#### **Addendum 38 – Regulation No. 39**

#### **Revision 1 - Amendment 1**

01 series of amendments to the Regulation – Date of entry into force: 18 June 2016

#### **Uniform provisions concerning the approval of vehicles with regard to the speedometer and odometer equipment including its installation**

Model A  
 (see paragraph 4.4. of this Regulation)

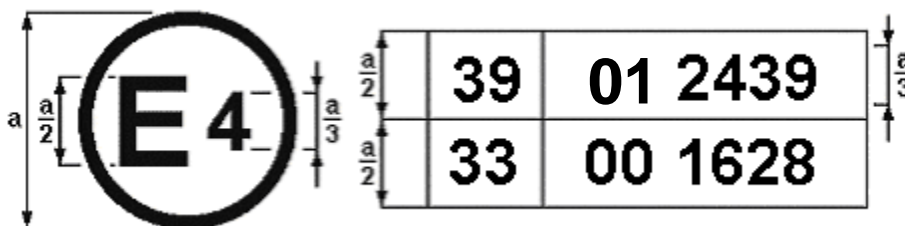
The above approval mark affixed to a vehicle shows that the vehicle type concerned has been approved in the Netherlands (E 4), pursuant to Regulation No. 39. The approval number indicates that the approval was granted in accordance with the requirements of Regulation No. 39 incorporating the 01 series of amendments.
